BOARD OF ADJUSTMENT MEETING AGENDA

NOVEMBER 21, 2023

1. (VAR 23-35) A request by Jose Villanueva to allow variances caused by an active lot spilt for a reduction in building setbacks and the minimum lot size requirements at 1008 N. D Street in the R-DP (Residential Duplex Patio) zoning districts

Variance Villanueva

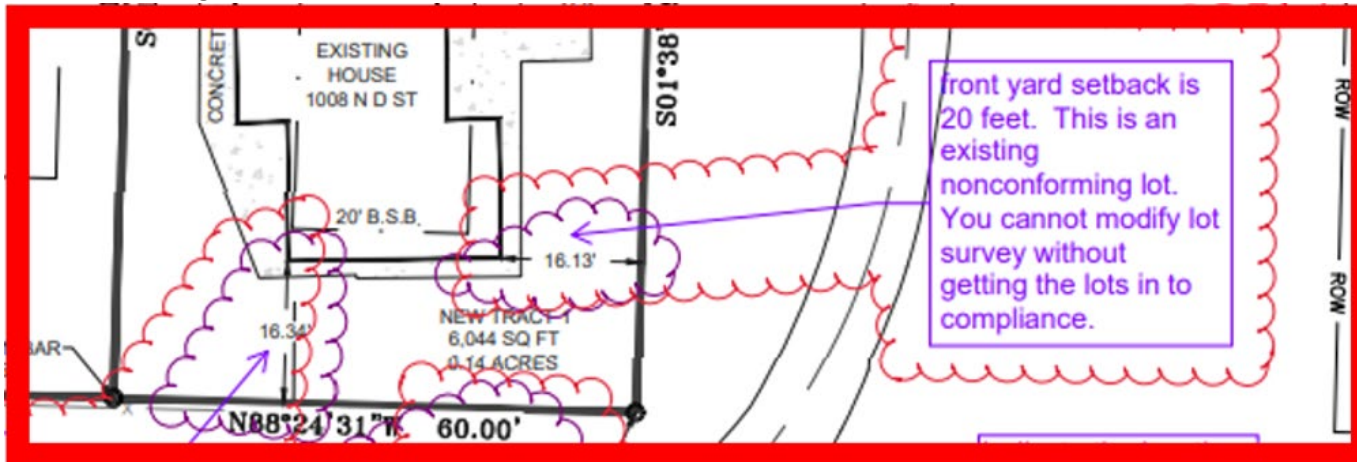
2. **The lot depth must be 100 feet.** Proposed lot split measures **60 feet**. I am asking to reduce this area **40 feet** to utilize the available space to build. (See image below)

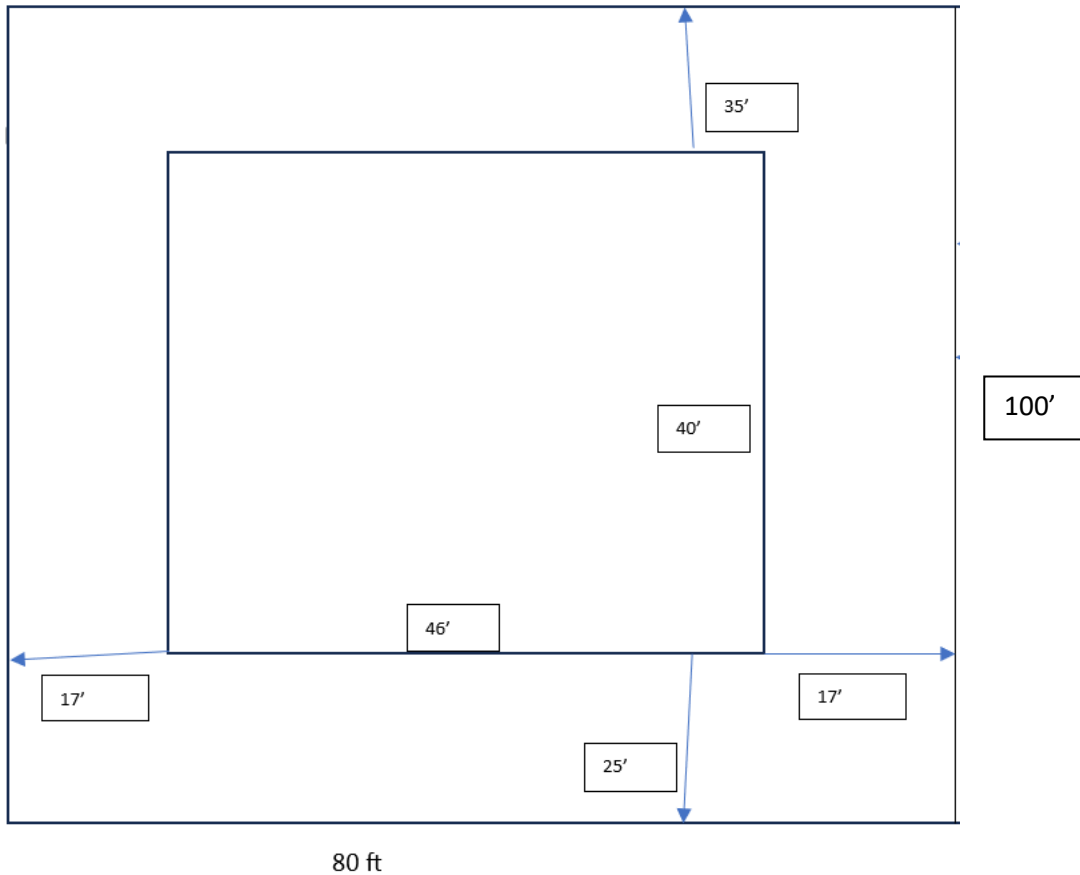
5. **Interior side yard setback is 6 feet.** Current setback measures **4.05 feet**. This is an existing non-conforming lot. I cannot modify lot survey without getting lots into compliance. Home was purchased in November 2017 and no modification was made to the sq footage since then. This marks a difference of **1.95 feet** (see Image below)

6. Note. Shed was completely removed.
